**CHABOT-LAS POSITAS
COMMUNITY COLLEGE DISTRICT
PURCHASING DEPARTMENT**

November 23, 2020

**Addendum No. 3
TEMPORARY FACULTY VILLAGE PROJECT
LAS POSITAS COLLEGE**

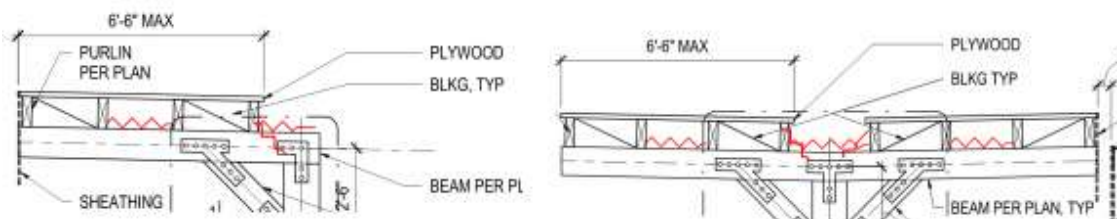
Question No. 4: Specifications list bird control devices with specifics on spikes and netting. After review of the drawings it's nowhere to be found on the drawings, please advise where area the bird control devices is applied.

RESPONSE: Bird control spikes are installed on top of each beam and support are as shown in red. Netting is not required.
